Date	Number	Page
4/23/12	<b>SC0363</b>	1(2)

## Bendix ATR-6 Valve, Permanent Repair

### SC0363, Bendix ATR-6 Valve, Permanent Repair

**FIGURE 1 - BENDIX® ATR-6™ TRACTION RELAY VALVE**

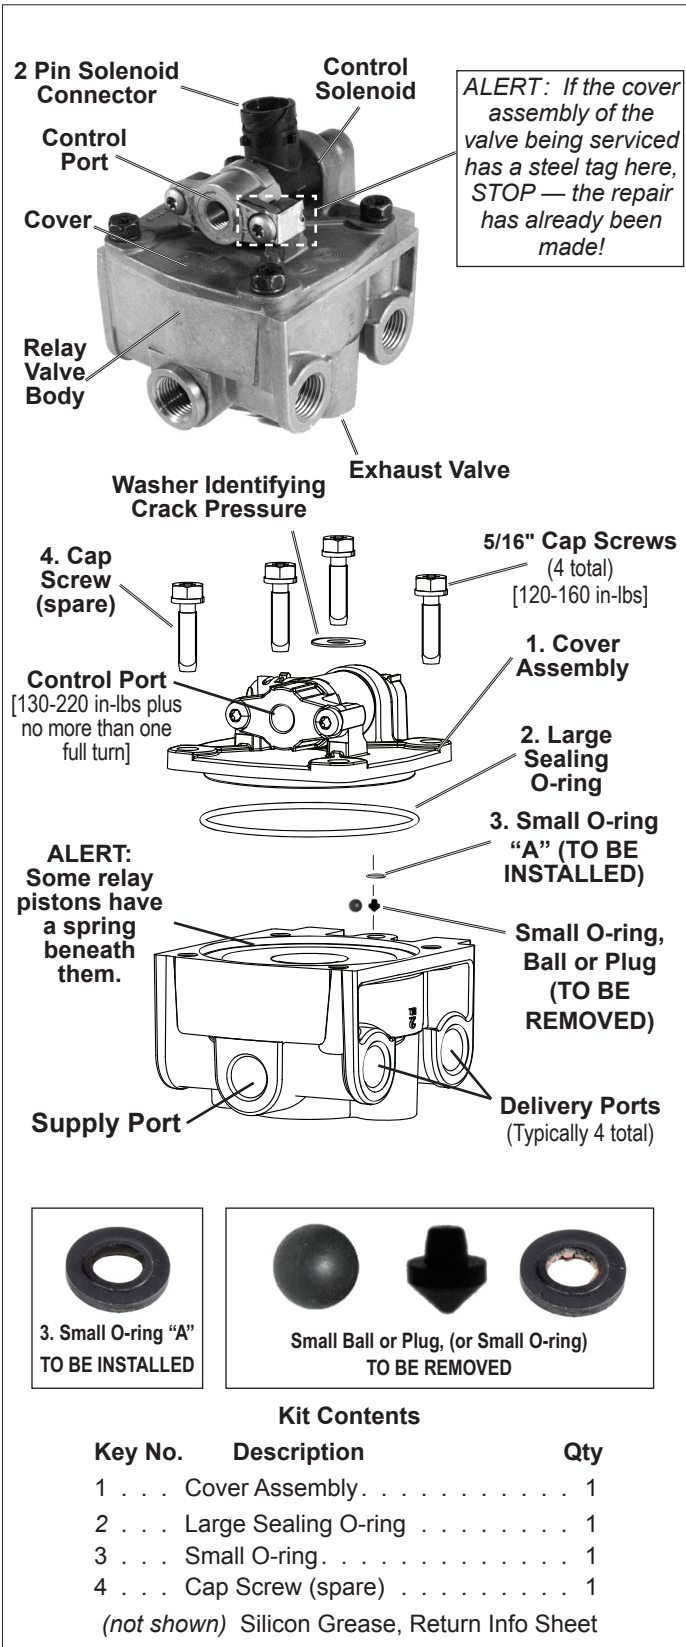
6. • **Remove and discard the ball or plug** (“A” in Figure 1) from between the cover and the valve, OR,  
• For ATR-6 valves that have not been serviced by a temporary disable kit, there will not be a ball or plug; **remove and discard the original small O-ring.**

8. Grease and install the new large sealing O-ring (2) and the small O-ring (3) supplied, into the NEW valve cover.
